## Sangiuliano, Tony (MTO)

RE: HIGHWAY 417 - CR29 STRUCTURE  
NON-CONFORMING PILES, SOUTH ABUTMENT  
WP 128-92-00 / 452-90-00  
OUR FILE: W.O. 4209

**RE:** Replacement of Piles  
South Abutment  
R.R. #29 Bridge  
Auriprior, Ontario

**Capacity of Out of Plumb Pile  
Highway 417-Regional Road 29 Underpass  
Ottawa, Ontario  
Contract No. 2001-0002**

**Installation Instructions****HARD-BITE POINT MODEL HP-77600-B**

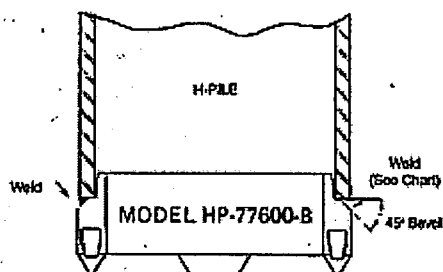
However, we have not as of 3.00 pm received word back from the designer regarding the use of Hard Bite APF model HP 77600 rock points.

Does Foundations support/recommend the use of the above note rock points?

The Hard Bite APF model HP 77600 rock points are considered as acceptable alternative rock points for the new piles to be installed on this particular project.

HP 310x110 with Rock Point

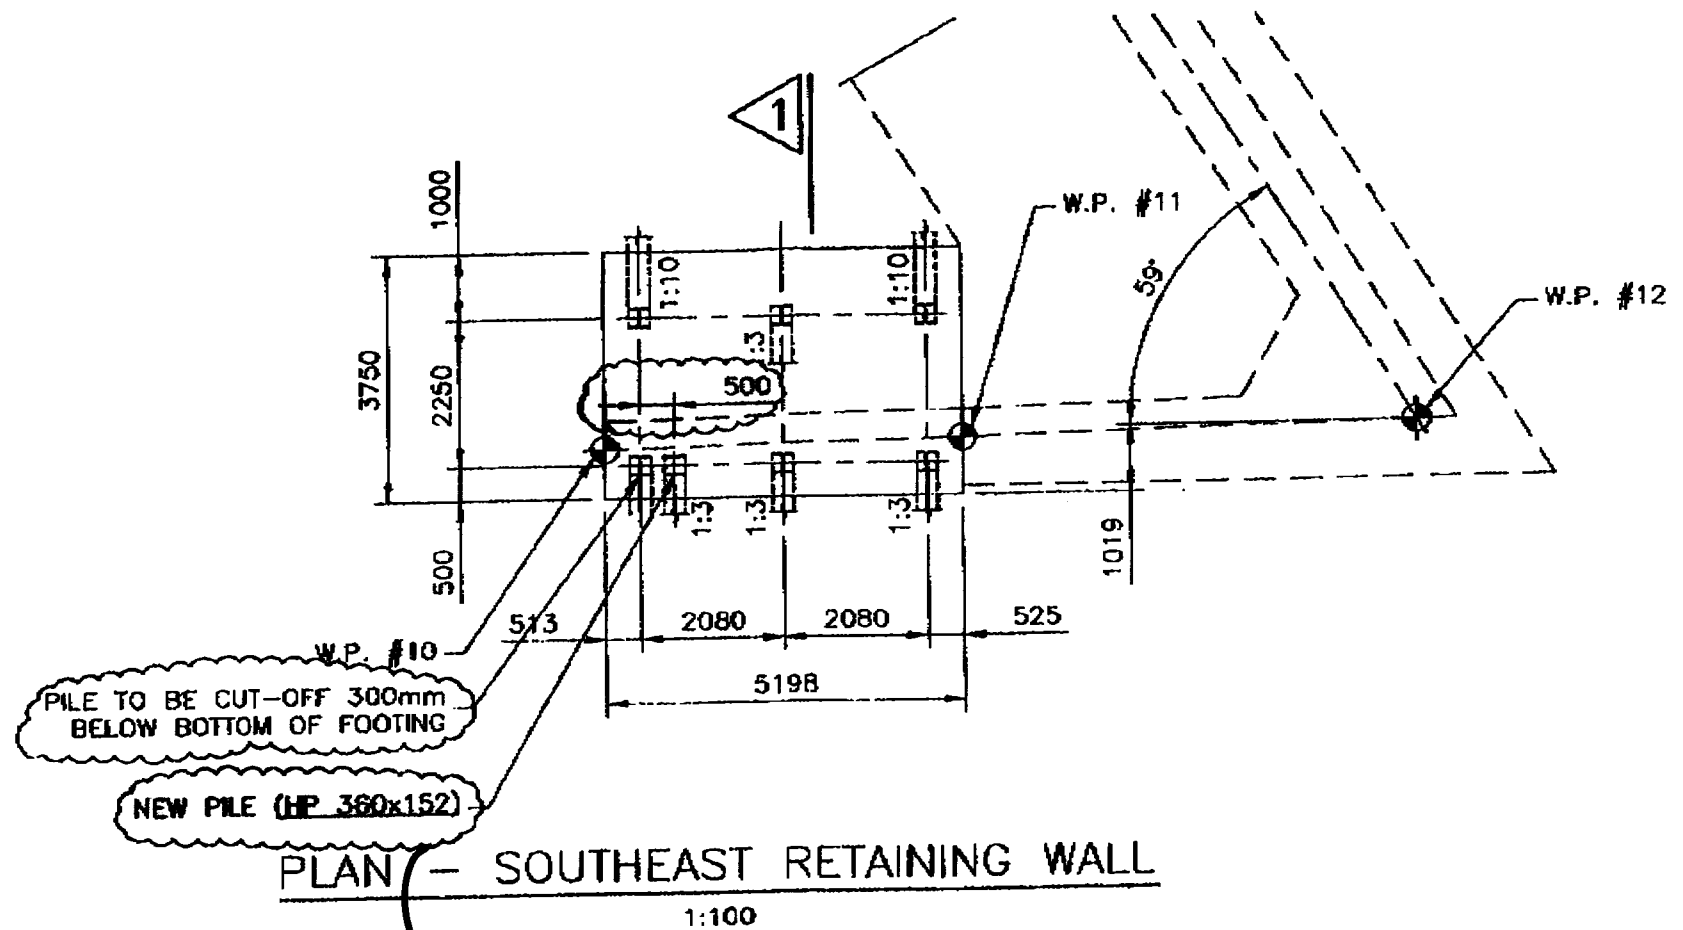
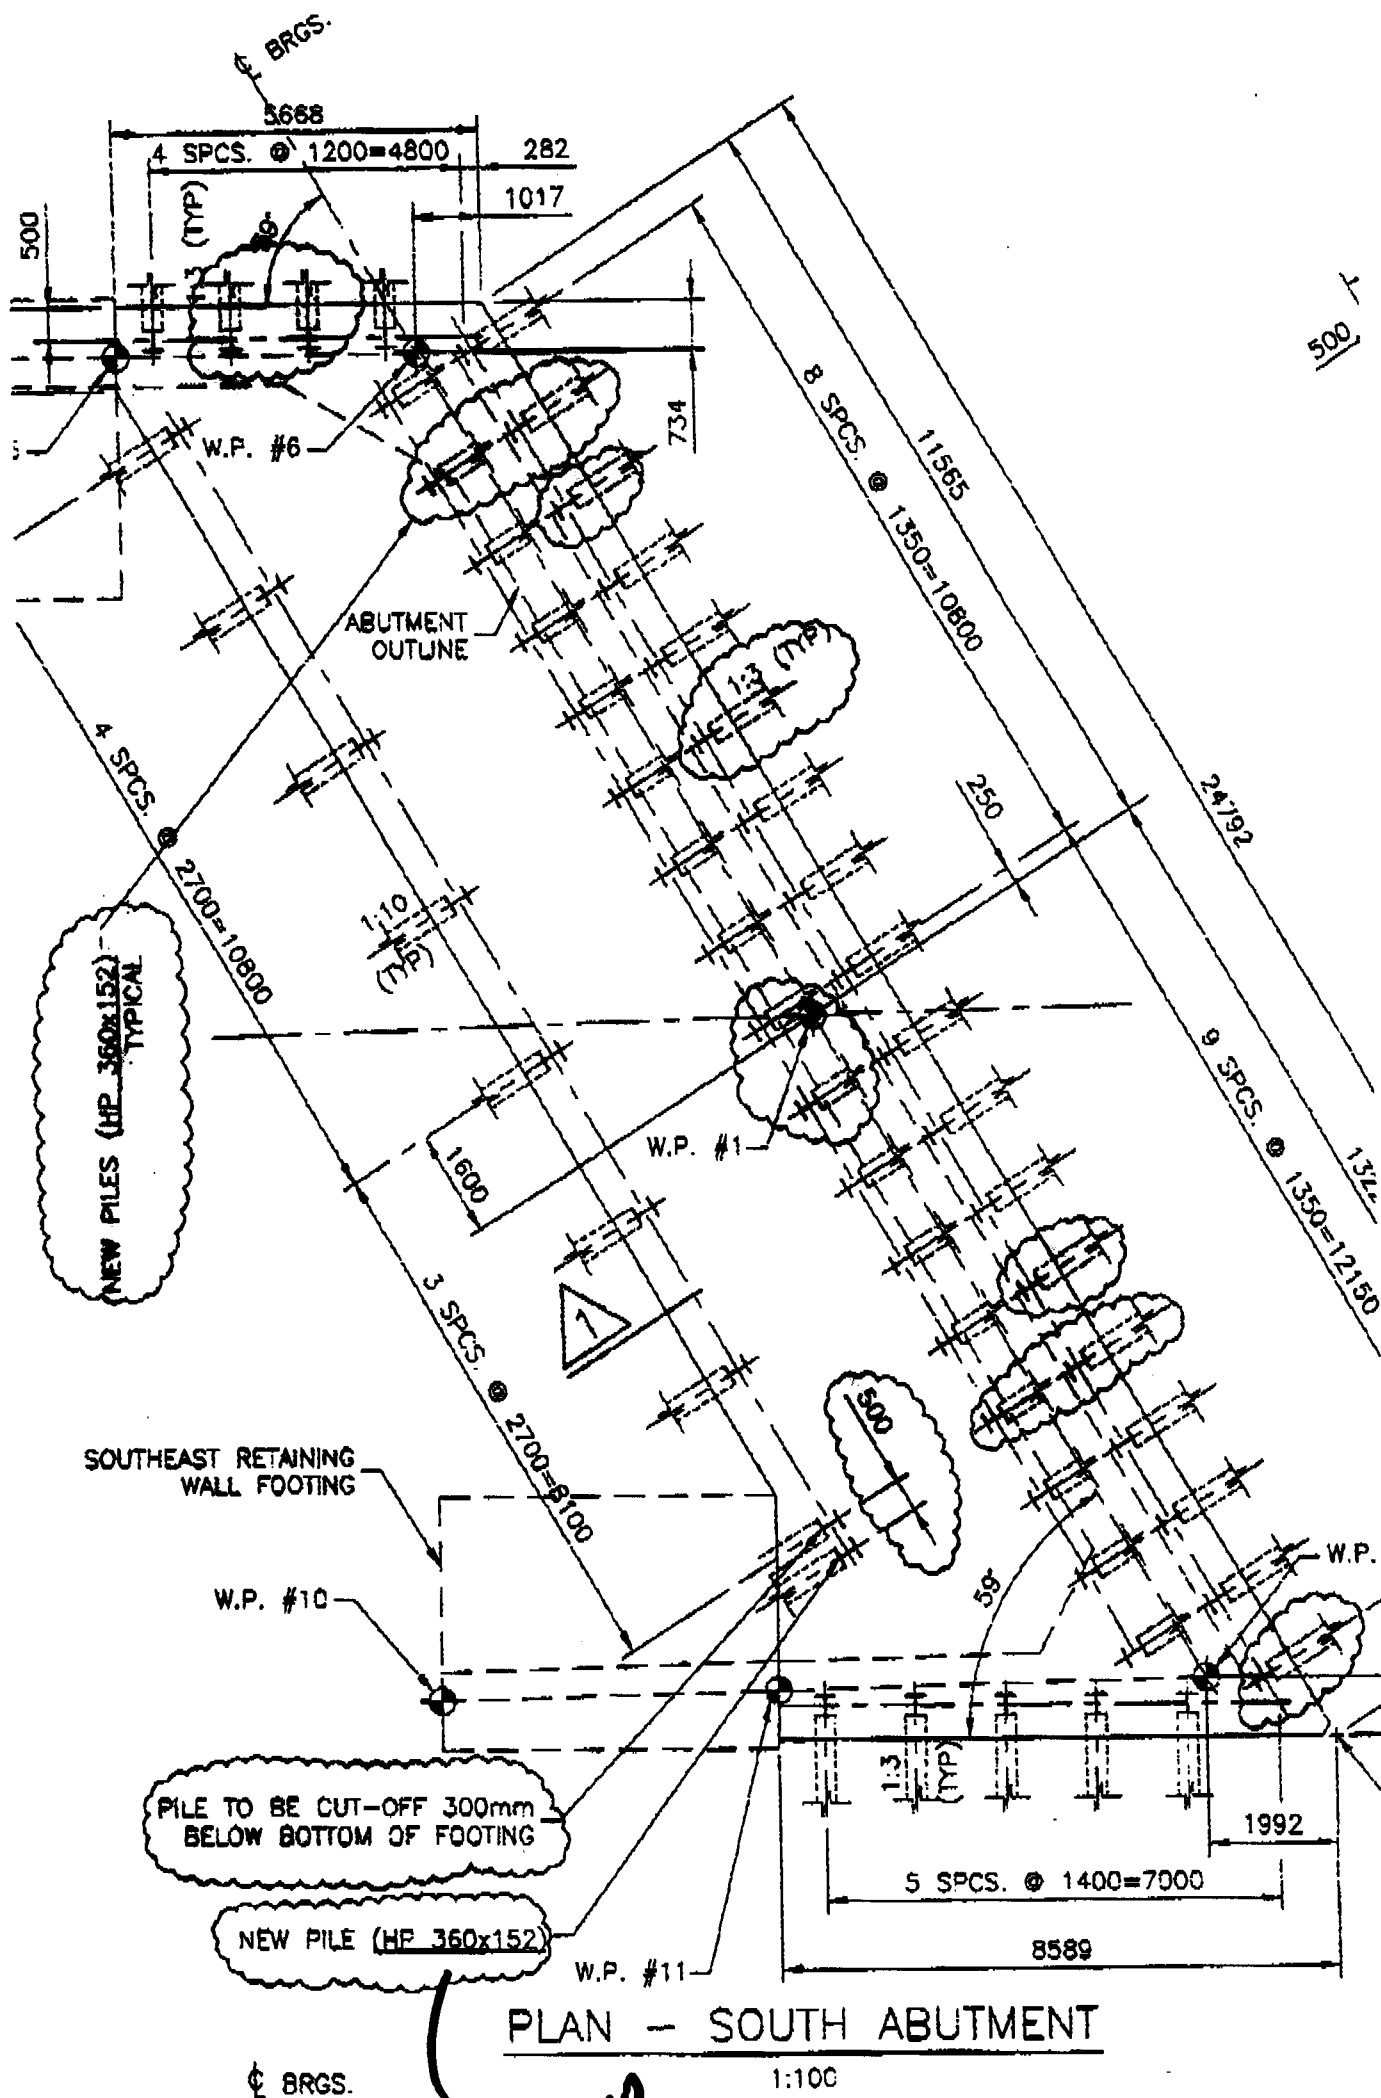
Risky for  
bent  
piles.

Risky for

x - does not conform with Code  
spacing

Option 1a - Extract the non-set piles  
and replace with HP 310x110  
Fitted with rock points and redrive
